Modification Report

*Moriah College, Queens Park
SSD-10532*

Director Alaine Roff
Associate Director Mietta Gleeson; Michael Beale
Project Code P0051073
Report Number VI

Figure 2 Extract of Proposed Building Eastern Elevation Comparison (Stage 1)

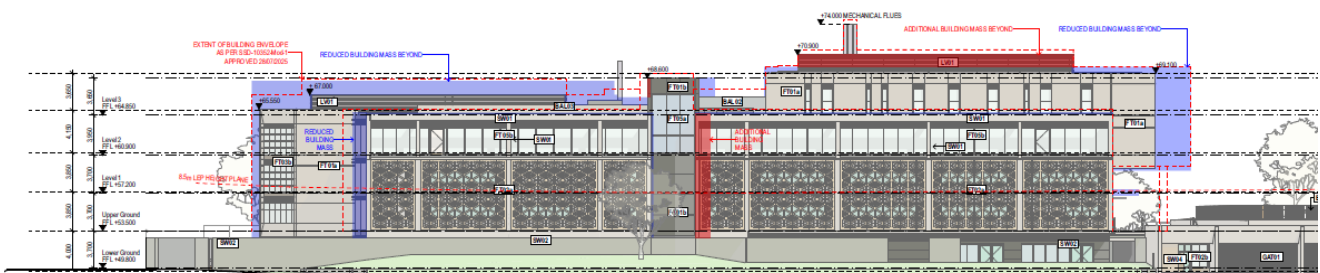
Minor modifications are proposed to the approved massing of the Stage 1 buildings. The key changes include:

- Reduction in the floor plate to the north at the upper levels, reducing the cantilever and removing three external structural columns.
- Reduction in the floor plate to the south at each level.
- Building floor to floor heights reduced resulting in a 500mm building height reduction.
- Reduction in overall building length (2300mm) responding to removal of useable area.
- Useable floor area reduced to southern circulation zone resulting in simplified façade alignment.

Comparison of the approved and proposed elevations are shown at **Figure 2**. The diagrams demonstrate that the proposed alterations to the building massing are minor and do not significantly change the approved bulk or scale of the approved development. The reduction in building height and length results from efficiencies in the design of the floorplate and servicing arrangements.

As highlighted, the changes predominantly result in a reduction in the building mass, with the higher portions of the building located away from the site boundary, consistent with the approval. As such, the modified design is not expected to result in any additional adverse amenity impact on the surrounds.

Figure 5 Proposed Stage 1 Landscape Masterplan

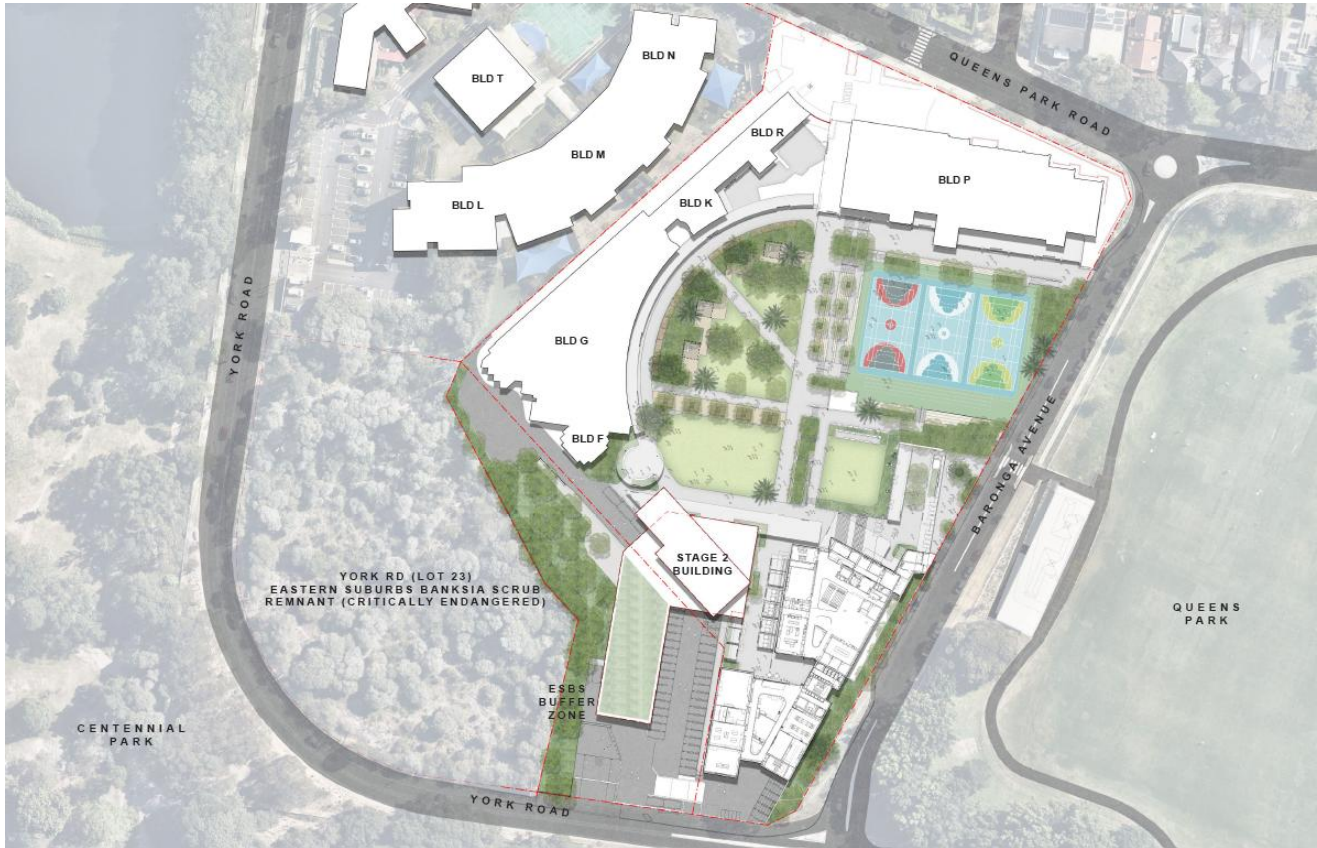
- Removal of green roof from the Gate 3 entry and awning to auditorium
- Rationalisation of seating terraces around sports courts
- Palisade fence added on top of wall along sports courts
- Alterations to trees and planters over auditorium
- Additional trees and gardens in entry forecourt
- Trees removed above substation and replaced by seats and raised planter with shrubs and groundcovers
- Increase in trees where timber decking and concrete has been removed south and east of the Sports Court
- General updates to reflect changes to the architectural plans.

The proposed modifications will result in an additional 22 trees on site. This minor increase in the tree count is as a result of replacing larger canopy trees with smaller trees that fit within tighter spaces, while continuing to provide for a significant canopy coverage (30%) and landscape coverage (24.8%) across the site. Further, it is confirmed that the proposed modifications do not seek to remove any additional trees beyond those approved in the original SSDA (SSD-10352).

The proposed removal of the green roof to the Gate 3 entry and auditorium awning responds to detailed design development. Notwithstanding this change, the entrance design has been enhanced through the introduction of additional trees and ground-level planters beneath the awning and along the site frontage.

Figure 6 Mark-up of approved photomontage of Viewpoint 1 (Queens Park)

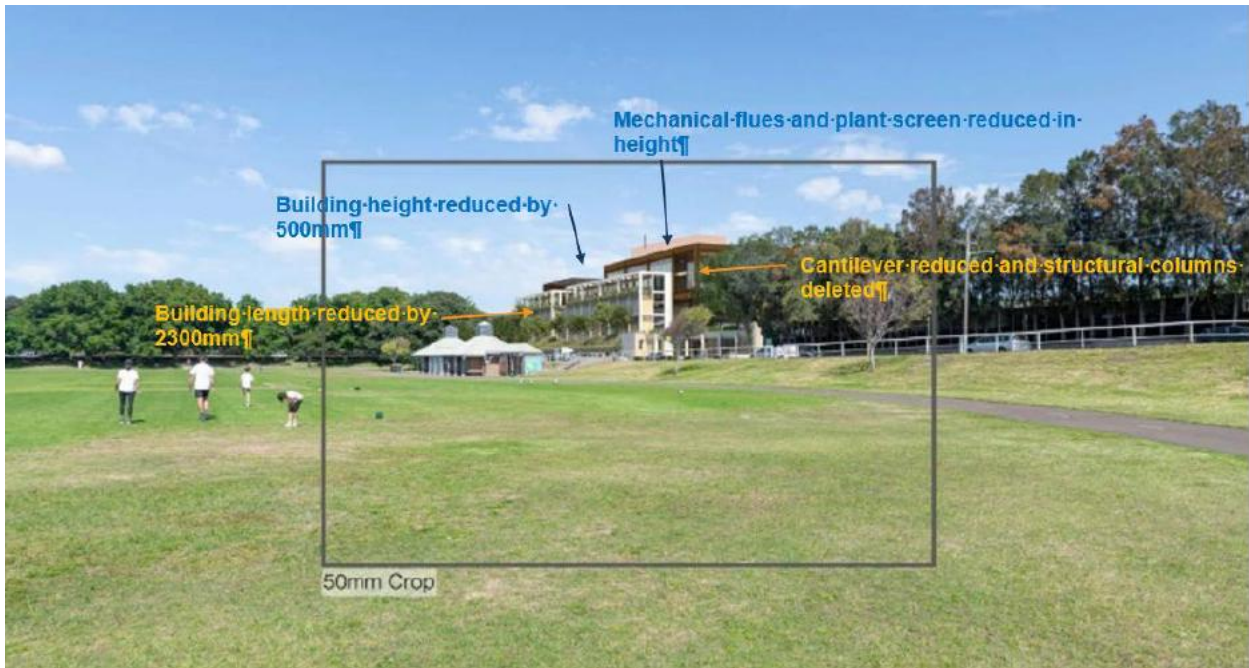
In views from the east, from Queens Park and surrounds, the modification would result in reduced visual impacts, as detailed in **Figure 6**. In views from the south and south east, the modification would result in similar reduced visual impacts. In views from the north and west, the development as modified would remain screened by topography and existing built form and would create negligible visual impacts.
